7 May 2015

RE: LINDT FACILITY PROJECT (SSD 14-6620) – SECTION 96 MODIFICATION – STATEMENT OF ENVIRONMENTAL EFFECTS

ATTACHMENT 1:
REVISED ARCHITECTURAL PLANS

Figure 5: Site Plan – As Proposed

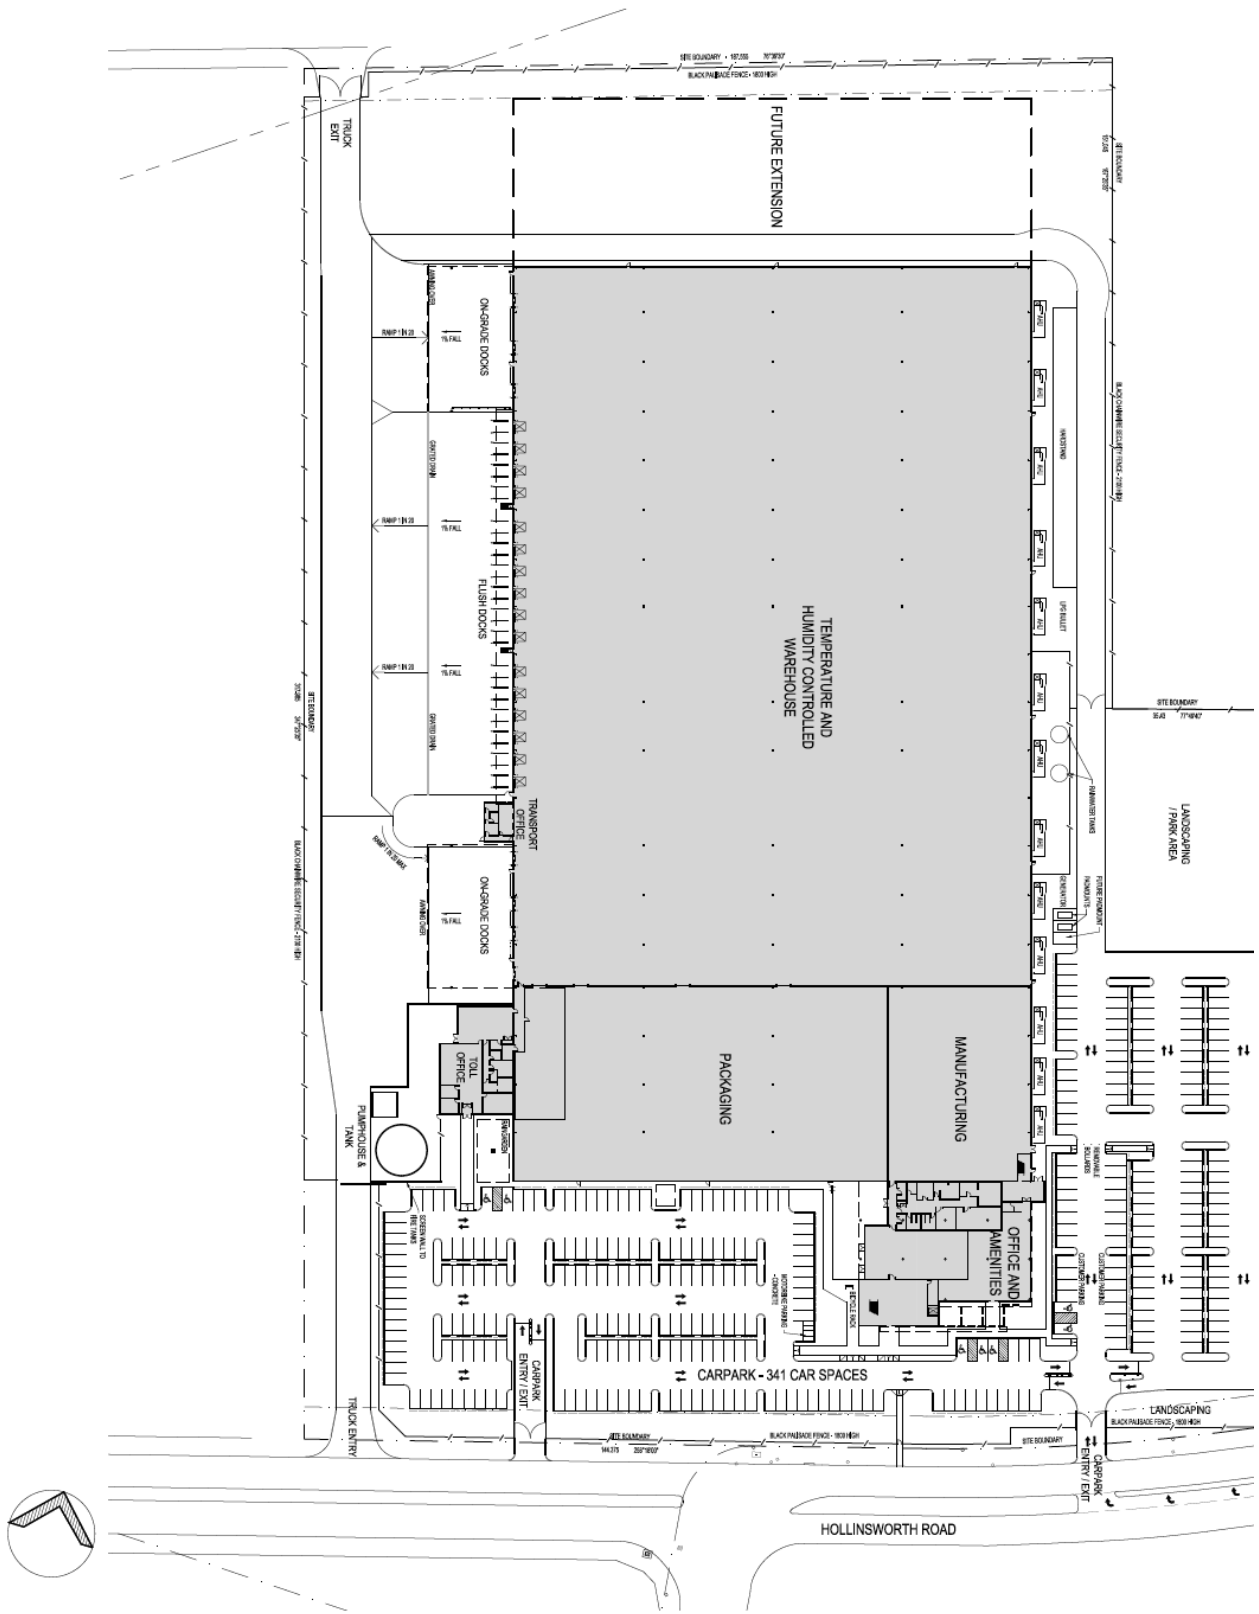
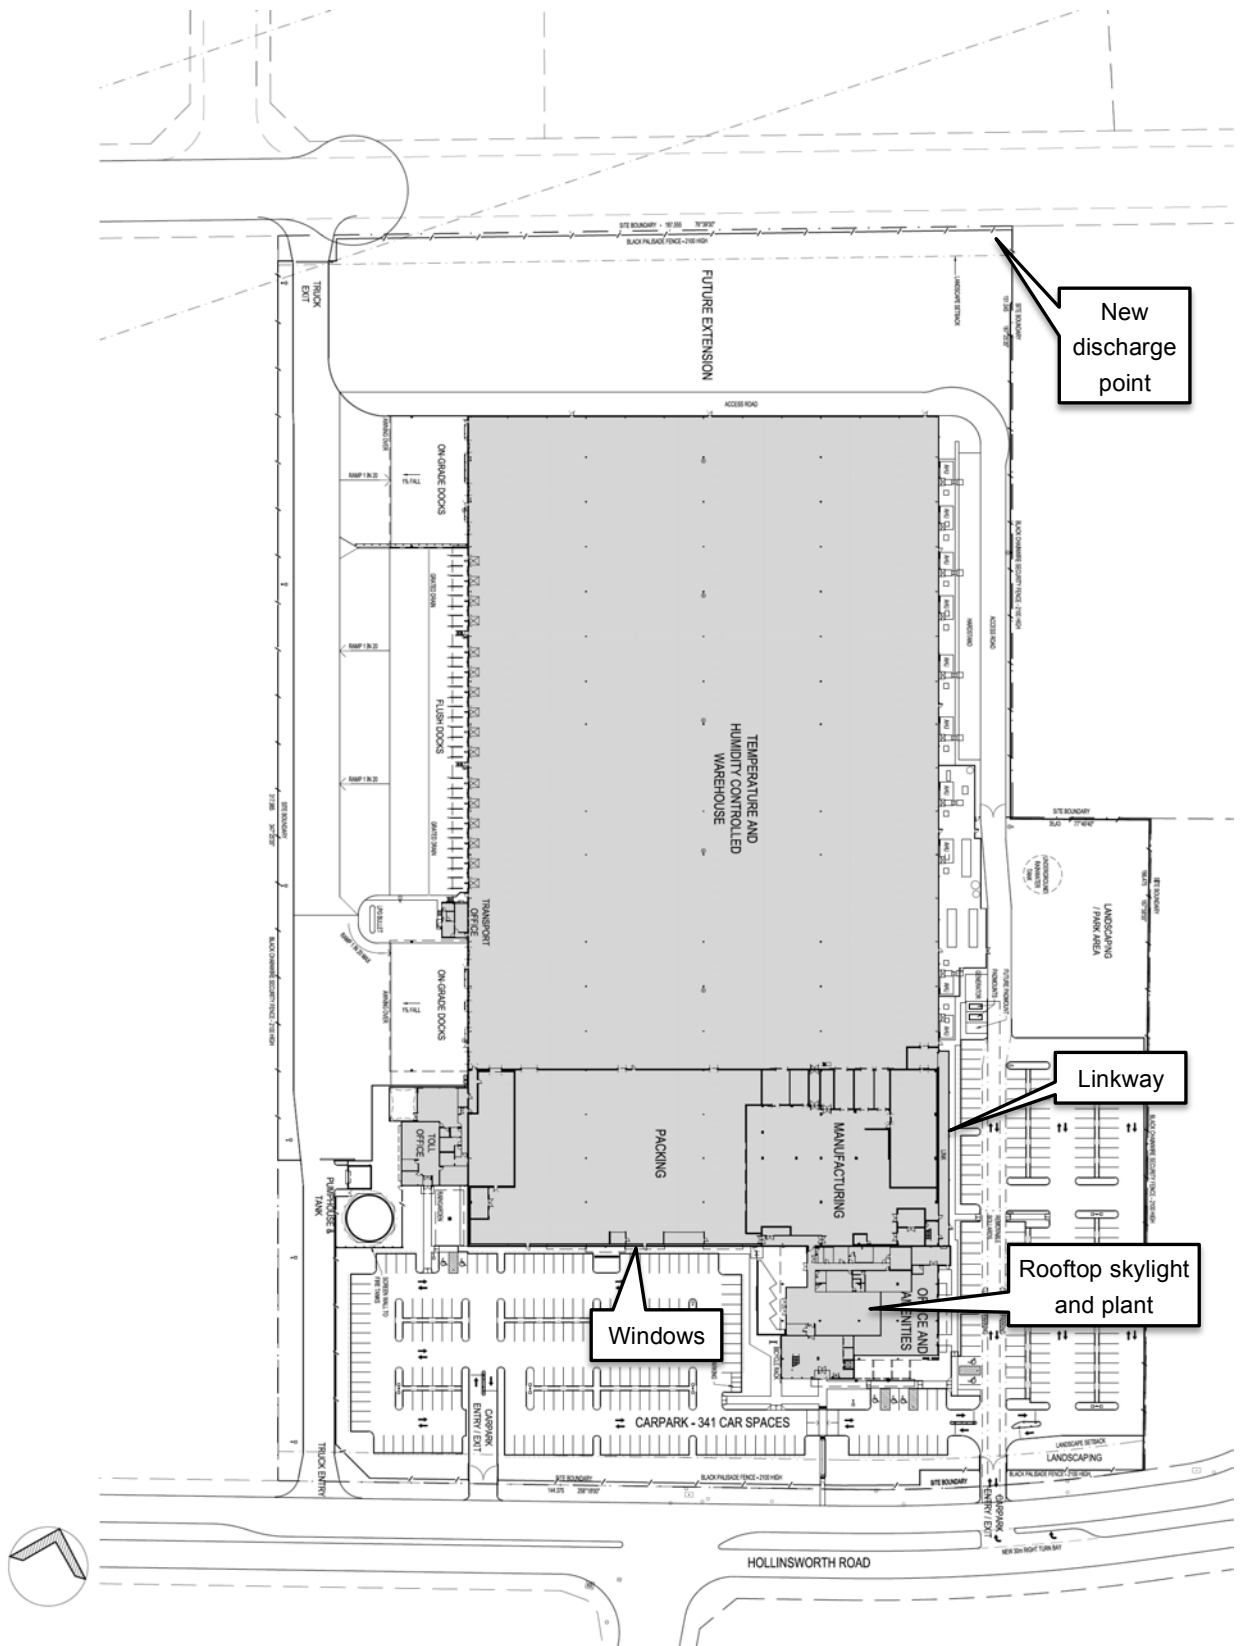
- *Link way added to eastern elevation* – an internal walkway has been added to the south-eastern corner of the facility to link the warehouse and manufacturing area with the showroom/factory outlet. External plant and equipment that was in this area has been relocated, including the rainwater tanks which would now be located underground below the eastern outdoor/park area;

- *Legal point of discharge location amended* – the stormwater point of discharge has been relocated from the north-western corner of the site to the north-eastern corner, with the change reflecting detailed stormwater design for the facility.

Figure 6: Elevations – As Proposed

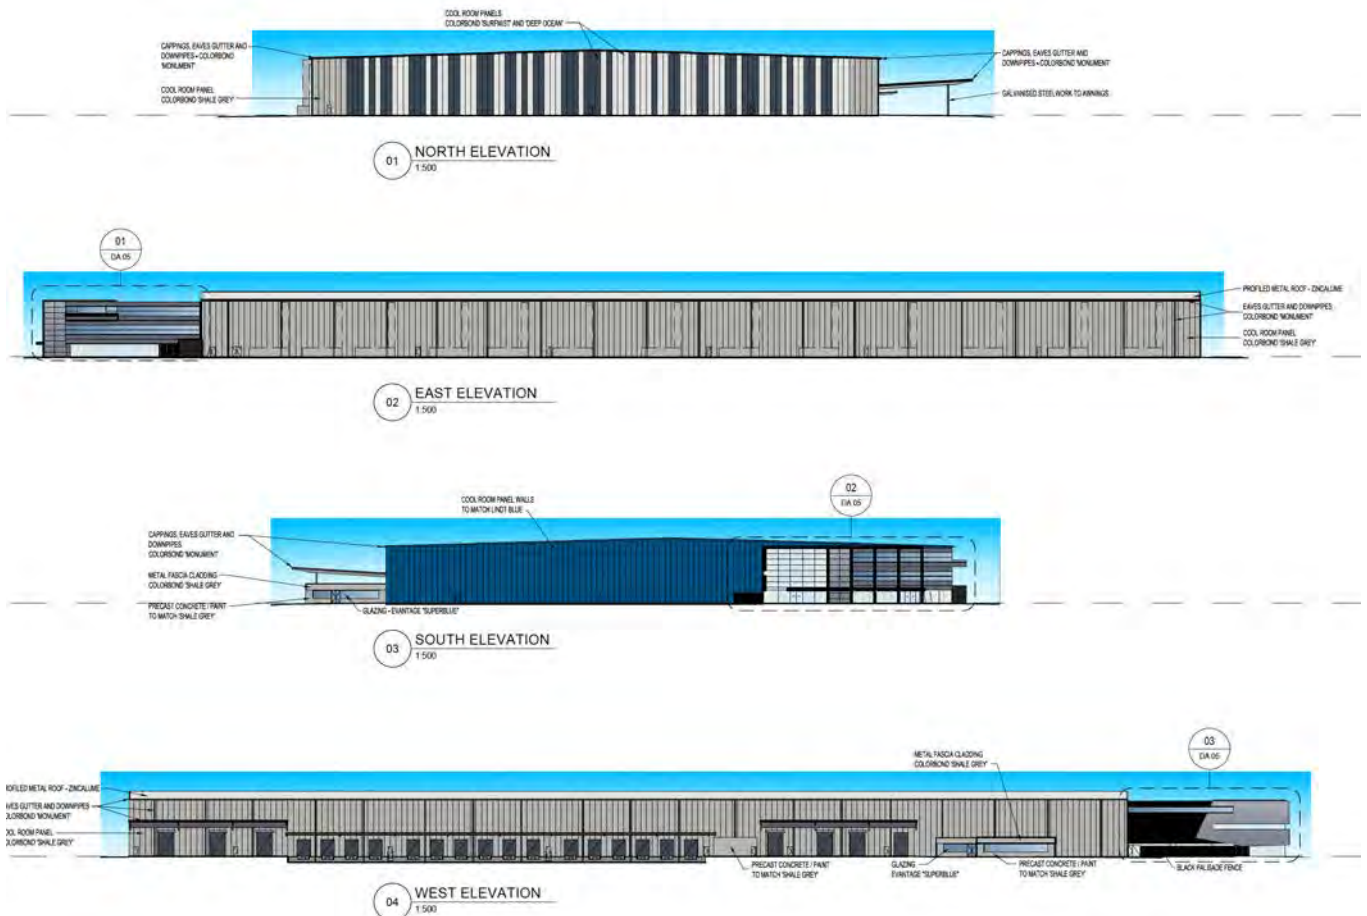
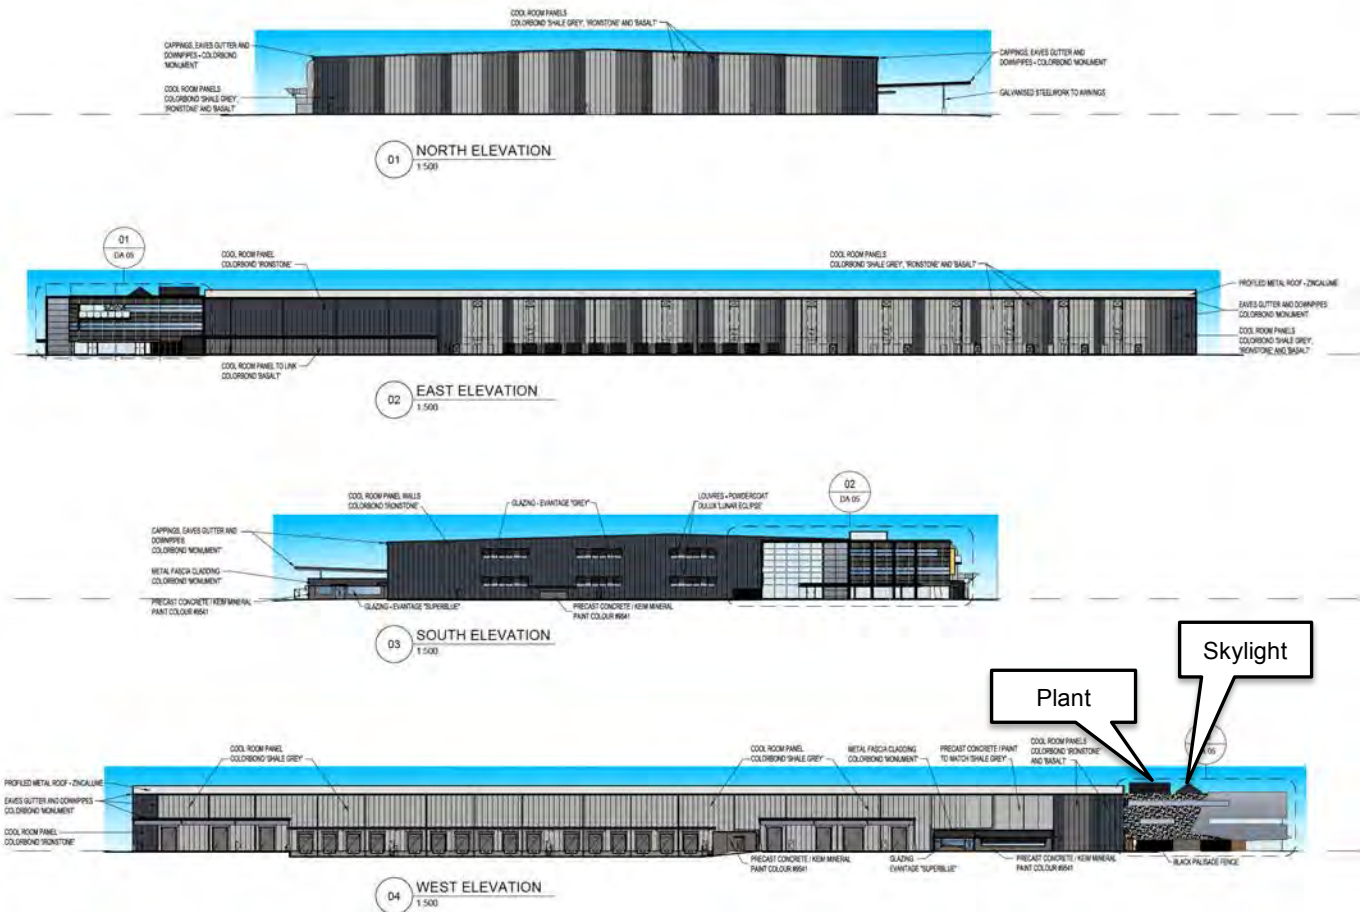
- *Windows added to southern elevation of warehouse* – a number of windows with louvres have been added to increase natural lighting and amenity for staff;

- *External colour schedule amended* - the colour schedule for the warehouse has been amended to provide greater visual interest and a more contemporary palette. In particular, the southern warehouse facade has been amended to integrate with the colour scheme on the other warehouse facades (nb. this façade was coloured blue on the approved plans), and the eastern elevation has been amended to provide greater variation;

- *Skylight and plant added to office roof* – a skylight has been added to the roof of the ancillary office to increase natural lighting and reduce energy use, and a rooftop plant area has been added to service the office. The plant area would be screened with louvres to integrate with the design of the facility and mitigate any visual impacts; and
